Richard L. Anderson
Vice President-Nuclear440-280-5579
Fax: 440-280-8029December 7, 2004
PY-CEI/NRR-2846LUnited States Nuclear Regulatory Commission
Document Control Desk
Washington, DC 20555Perry Nuclear Power Plant
Docket No. 50-440
Responses to Requests for Additional Information Regarding In-Service Examination
Program Relief Requests IR-050, IR-051, and IR-052 (TAC Nos. MC3169, MC3170 and
MC3171)

**RESPONSES TO REQUESTS FOR ADDITIONAL INFORMATION REGARDING
PERRY NUCLEAR POWER PLANT IN-SERVICE EXAMINATION PROGRAM
RELIEF REQUESTS IR-050, IR-051 AND IR-052**

N3 NOZZLE ASSEMBLY
(STEAM OUTLET)

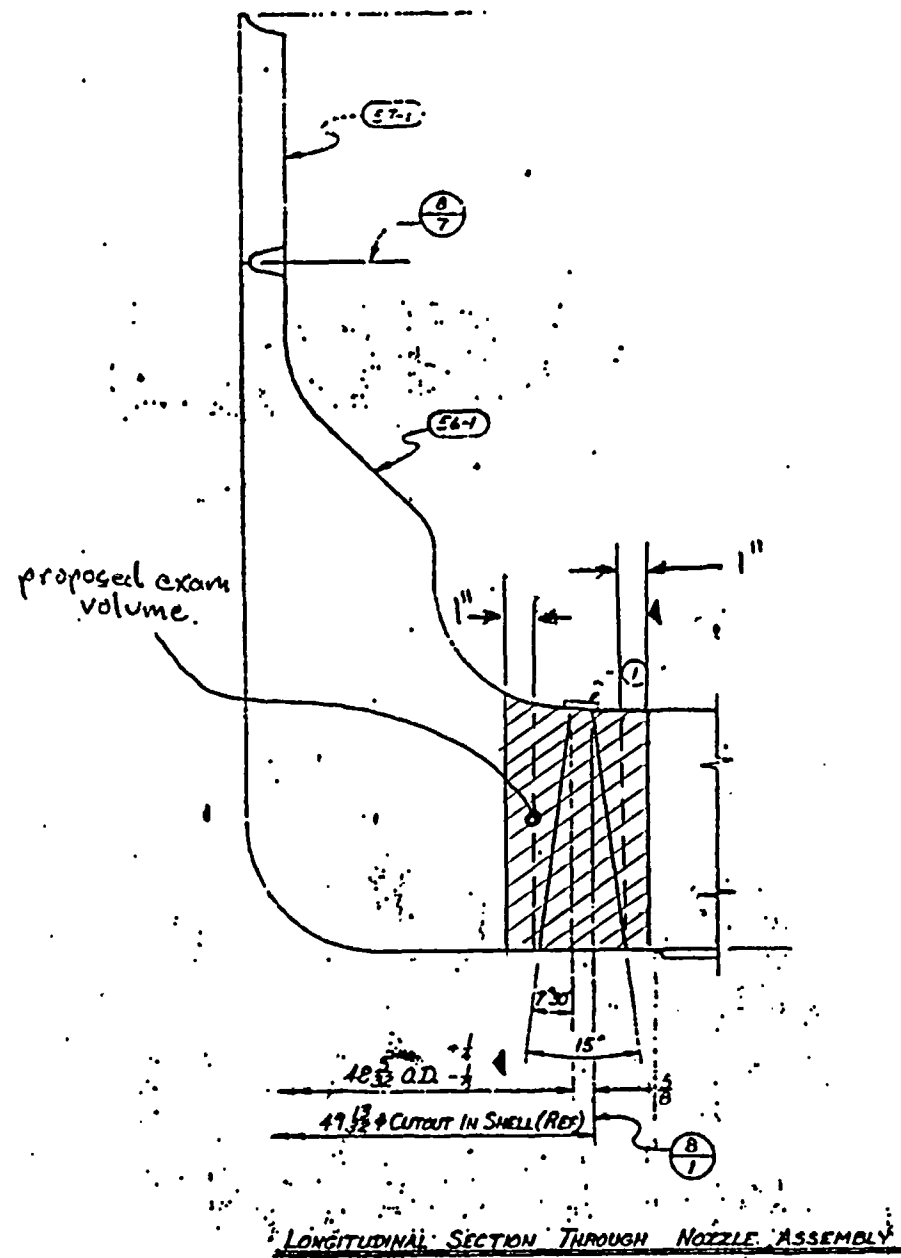
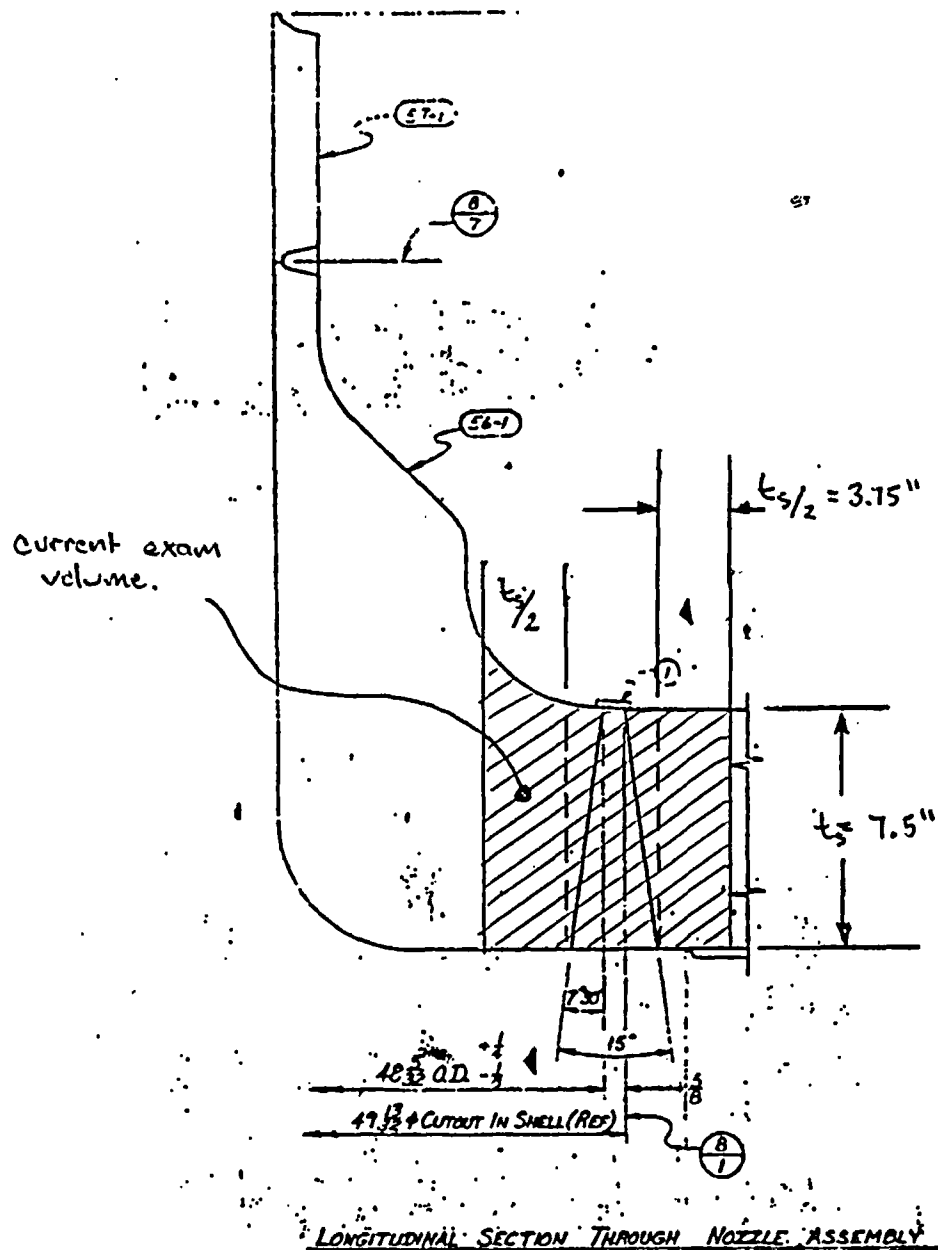
In accordance with guidance provided to staff for review of relief requests, provide detailed drawings which depict the examination volume that has been examined during previous inspections and the proposed examination volume. The weld sketches should show the exact dimensions of the as installed welds and the positions of any repairs to those welds so that the licensee will be able to precisely locate the extremities (widest sections) of the nozzle-to-vessel welds and any repair weld areas so that the new examination volumes will encompass these repair weld areas.

- (a) Discuss the documentation available of the actual cross-sectional dimensions and precise locations of repaired areas for all RPV nozzle-to-vessel welds at PNPP. Discuss the process for defining new examination volumes that encompass these repair weld areas.
- (b) If examination personnel are to identify the extremities (widest sections) of the nozzle-to-vessel welds, what positive means of examination will be used to identify the weld extremities, such as, weld etching, etc.? Will the weld extremities be identified on both the inside diameter and outside diameter of the vessel to ensure complete coverage of the welds?

As stated in IR-052, all of the PNPP's nozzles are of the configuration depicted by ASME XI Figure IWB-2500-7(b). The PNPP's vessel was fabricated by Chicago Bridge and Iron – Nuclear (CBIN). Attachment 2 provides the CBIN drawing for the Main Steam Nozzle-to-Vessel weld and mark-ups of that weld configuration denoting the current ASME XI required coverage and the proposed coverage. This configuration is typical of all of the subject nozzle-to-vessel welds.

Since fabrication, there have been no repairs to any of the PNPP's nozzle-to-vessel welds. Detailed records of the in-process repairs that were made to the nozzle-to-vessel welds during fabrication are not available. Until such time that the Nuclear Regulatory Commission (NRC) staff formally approves Code Case N-613-1, to ensure that the in-process repairs are encompassed in the examination areas, the PNPP staff will extend the Code Case N-613-1 examination volume out from ½ inch on either side of the weld to 1 inch on either side of the weld (see Attachment 2).

All of the subject nozzle-to-vessel welds were made using the Submerged Arc Welding method with the root of the weld being on the outside of the vessel and the face of the weld being on the inside of the vessel (see Attachment 2). As such, the widest section of the weld is not visible to the examination personnel. Complete coverage is determined by calculating the weld width from the drawings and scanning the appropriate distance on either side of the weld centerline, which was marked with punch marks by CBIN when the vessel was fabricated.
